FITCHBURG, MASSACHUSETTS - LOCAL PROTECTION PROJECT

SEMI-ANNUAL INSPECTION

22 October 2003

LOCAL FLOOD PROTECTION PROJECT INSPECTION REPORT

Photo 5: Looking downstream from the Sheldon Street Bridge

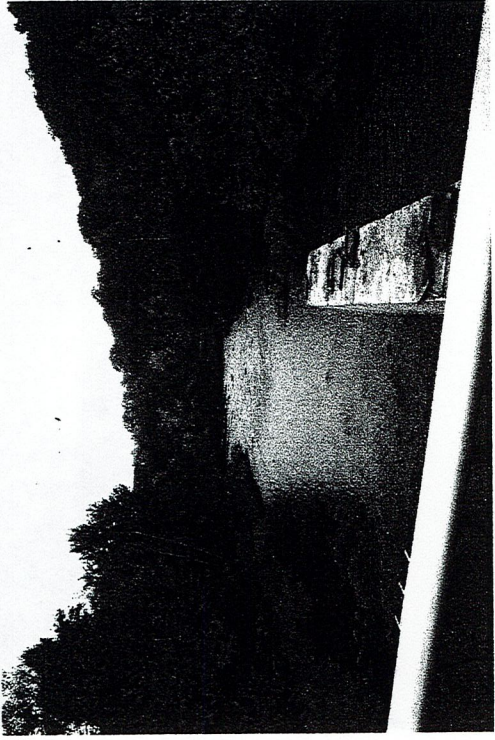
Looking downstream - Brush, trees, and other undesirable vegetation are present on both banks. A shoal is present on the left bank (see photograph # 5).

Photo 6: Looking upstream from the Sheldon Street Bridge

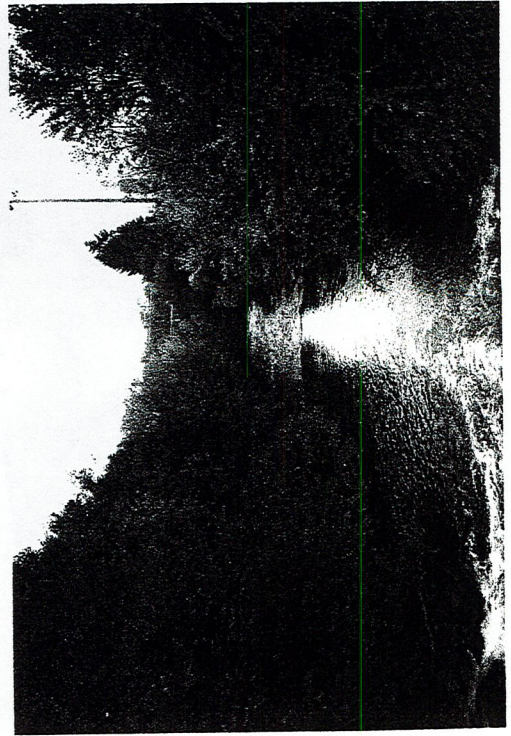
Looking upstream - Woody vegetation and shoals are present on both banks (see photograph # 6).

Photo 7: Looking downstream from the Lower River Street Bridge

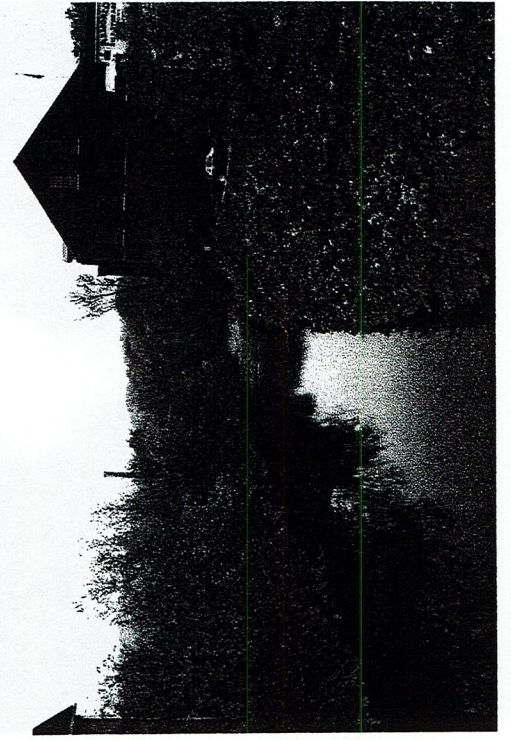
Looking downstream - The large shoal on the left bank should be removed.
Vegetation should be removed from both banks (see photograph # 7).

Photo 11: Looking upstream from the Putnam Street Bridge

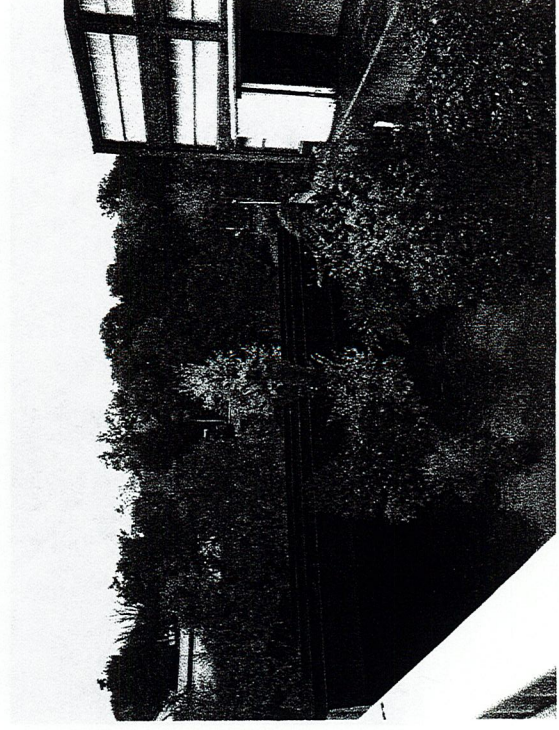
Looking upstream – There is heavy growth of trees and vegetation in the training walls along both sides of the river, extending well upstream of the railroad bridge. This is also a narrow stretch of the river and should be kept free and open. The shoals on the north (right) bank approximately 100 yards above the railroad bridge and under the right span of the railroad bridge should be removed. The large shoal in the center of the channel about 200 yards upstream of the railroad bridge should be removed. The large elm growing on a shoal at the center bridge pier and the shoal at the railroad bridge center abutment should be removed (see photographs # 11 & 12).

Photo 13: Looking downstream from the Putnam Street Bridge towards the Riverfront Park on the right bank

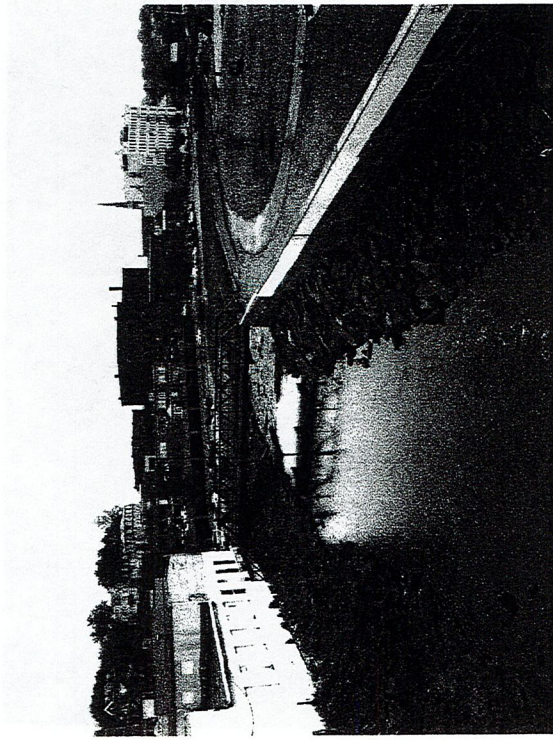
Looking downstream - All trees, brush and other vegetation has been cut and removed from within the floodwalls and riprap along both sides of the river extending from the Putnam Street Bridge to the just beyond the Cushing Street bridge in conjunction with the new riverfront park (see photographs # 13, 14, 19, 20, 21, 22, 23, 24 25 & 26).

Photo 14: Looking downstream from the Putnam Street Bridge towards the Riverfront Park. Note the floodwall, which is part of the federally-constructed Fitchburg Local Flood Protection Project

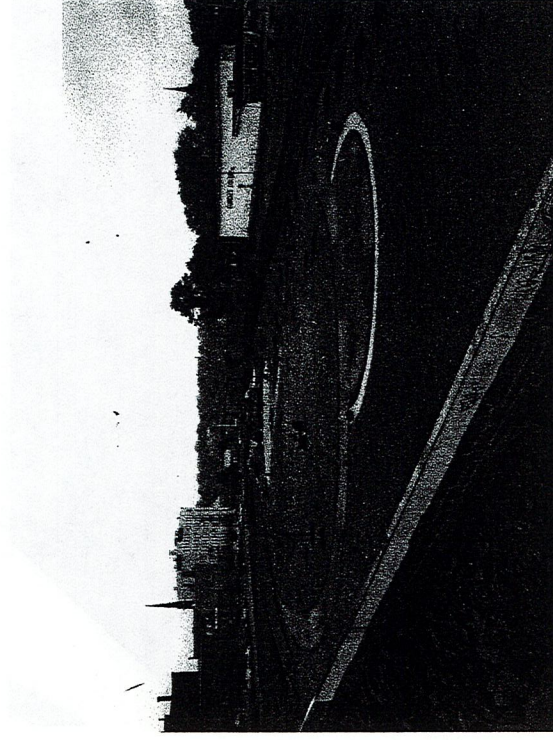
During the inspection, Fitchburg Economic Development Office Executive Director Mr. Mike Lanava asked about the feasibility of removing the concrete floodwall between the Riverfront Park and the North Nashua River, so that visitors can see the river from the park. This floodwall is part of the flood control project and provides over bank protection during significant events. Mr. Faloretti explained that the Corps would not approve removal of any project feature unless it could be reconstructed in another location (such as the western edge of the park near the railroad right of way, in the case of this floodwall) and provide the same level of protection as the original feature.

The city should closely coordinate any such proposals with the Corps of Engineers to insure that the proposal will not negatively impact the function of the project.

Photo 15: Looking downstream from the Laurel Street Bridge

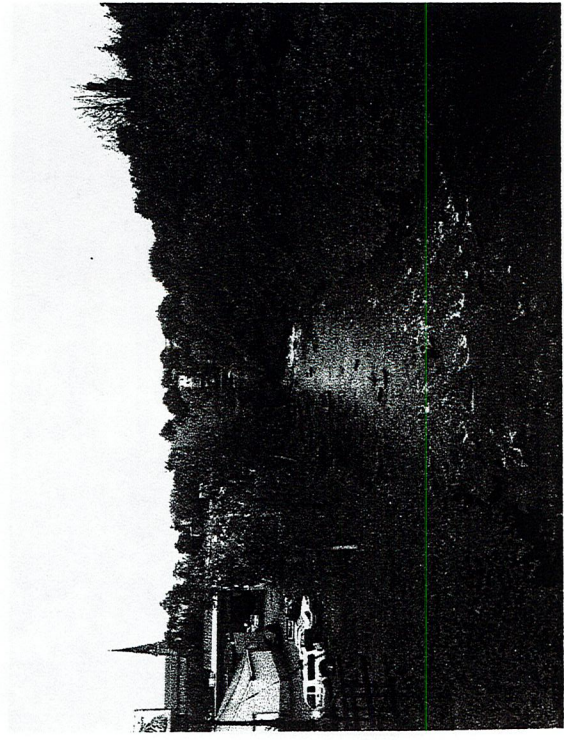
Looking downstream - The channel narrows downstream of a manhole on the right bank. The trees, brush and vegetation growing along both banks should be removed (see photograph # 15).

Photo 31: Looking downstream from the Airport Road Bridge

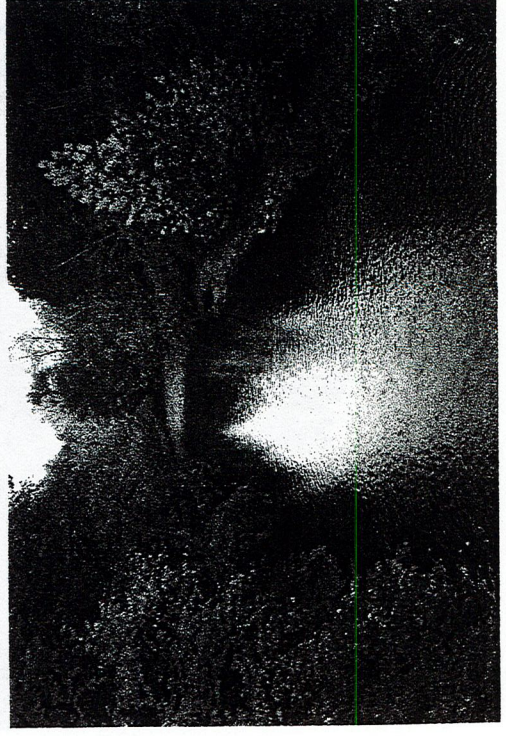
Looking upstream - Brush and trees are present along both banks. There are trees in the channel at the abutments and on the shoal on the left bank (see photograph # 31).
